To: T10 Technical Committee  
From: Robert Sheffield (Robert.L.Sheffield@intel.com), Intel Corporation  
Date: May 12, 2004  
Subject: T10/04-030r2, SAS-1.1: Fix SP Hang States

### **Overview**

Replace figure 69 – SP (phy layer) state machine – speed negotiation states with the following figure:

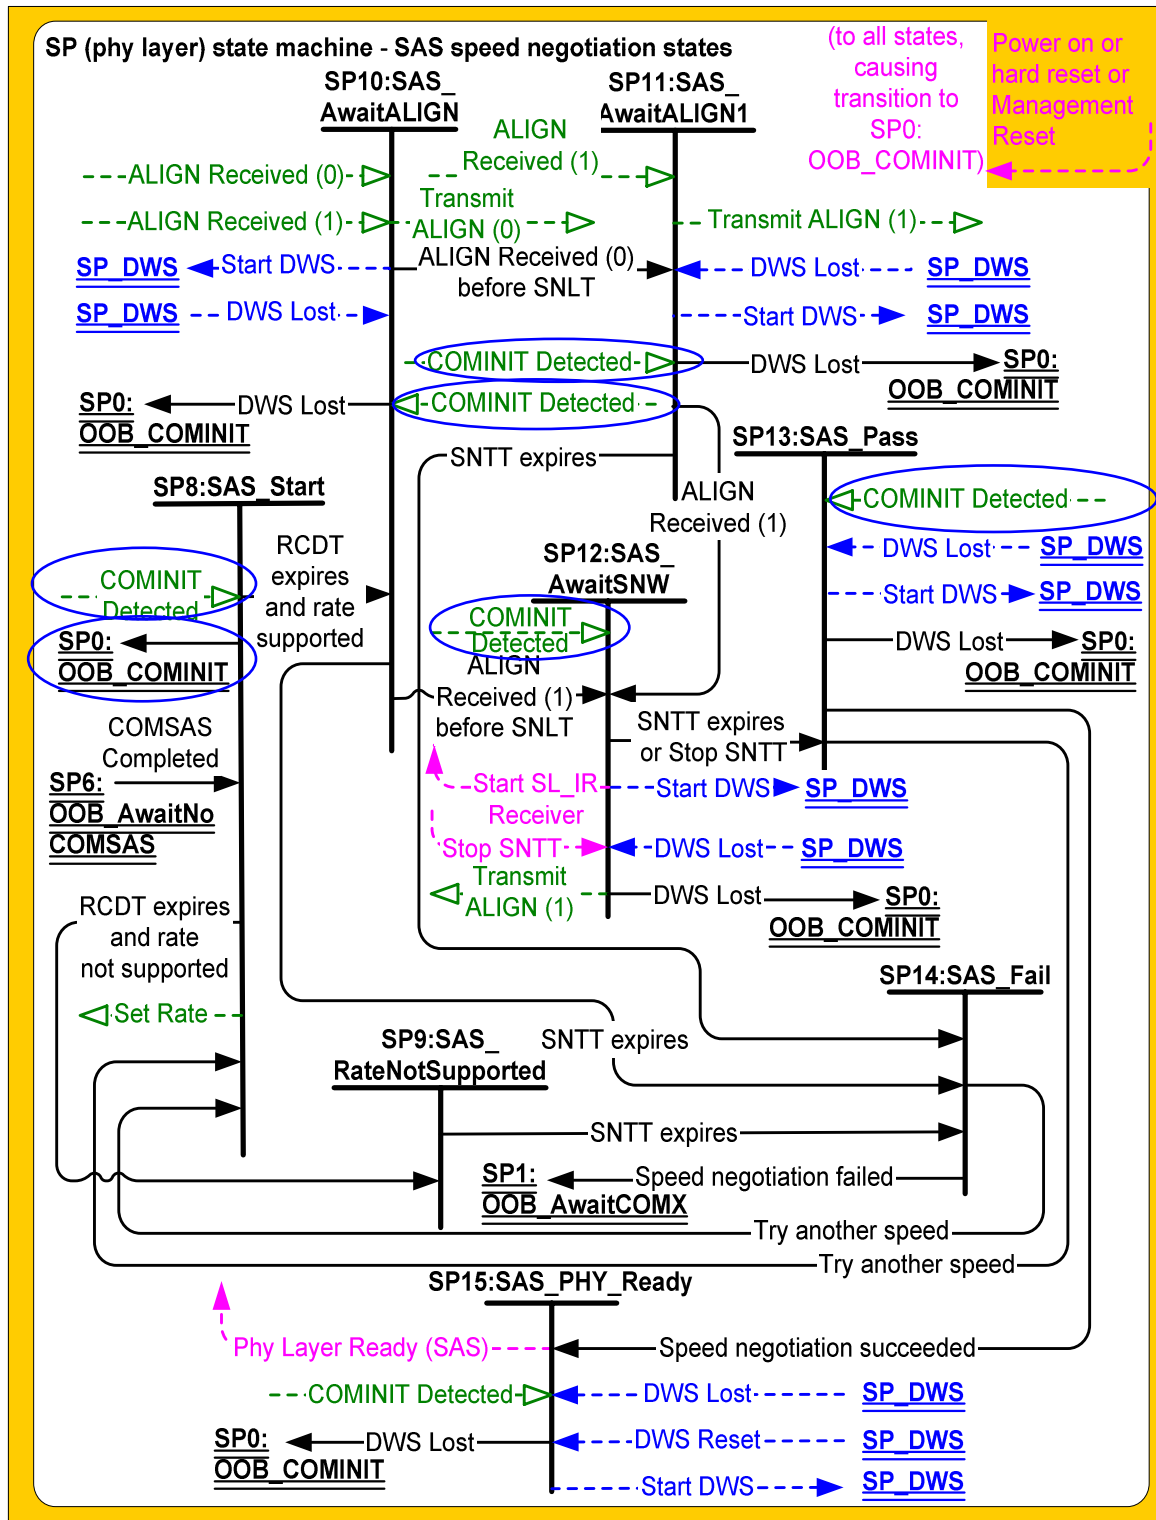
*Modify subclause 6.7.3.9 as shown to define COMINIT Detected as a trigger for the transition to SP0, and the transition to SP26 for spinup-hold:*

This transition shall occur after receiving a COMINIT Detected message.

**6.7.3.9.3 Transition SP7:OOB\_AwaitCOMSAS to SP26:SATA\_SpinupHold**

This state shall send a SATA Spinup Hold confirmation to the link layer and this transition shall occur if,

- a) this phy is in an expander device;
- b) this phy supports attachment to a SATA device;
- c) the COMSAS Detect Timeout timer expires;
- d) this expander device implements SATA spinup hold; and
- e) the value of the MgmtReset machine state variable is zero.

**Figure 72 — SP (phy layer) state machine – SATA Spinup Hold State**

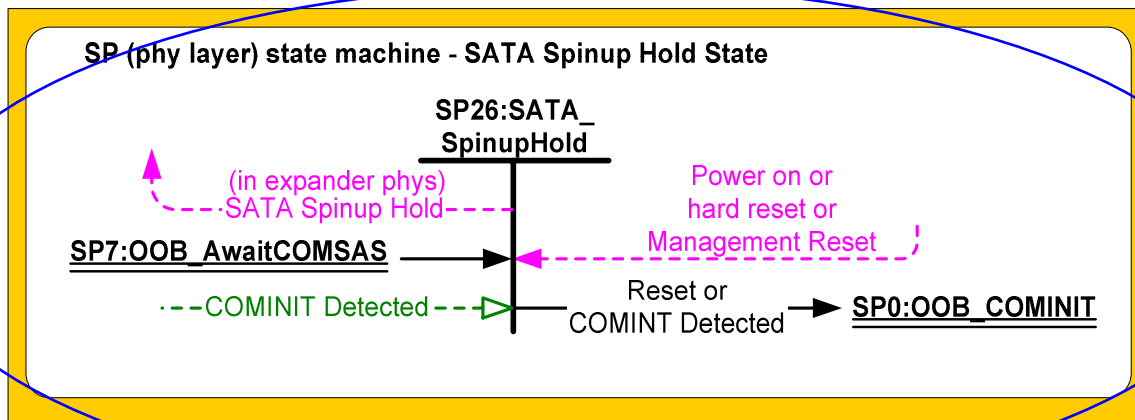
Figure 72 shows the SP26:SATA\_SpinupHold state. This state shall be entered from the SP7:OOB\_AwaitCOMSAS state upon detection of a COMSAS detect timeout if the phy supports SATA, the phy supports Spinup Hold, and the MgmtReset state machine variable has a value of zero.

This transition shall occur if this state receives a COMINIT Detected message, a Management Reset request from the management layer, a hard reset, or a power on. If this transition is caused by a Management Reset Request from the management layer, it shall cause MgmtReset to be set to one upon entry to SP0:OOB\_COMINIT. Otherwise, MgmtReset shall be set to zero upon entry to SP0:OOB\_COMINIT.
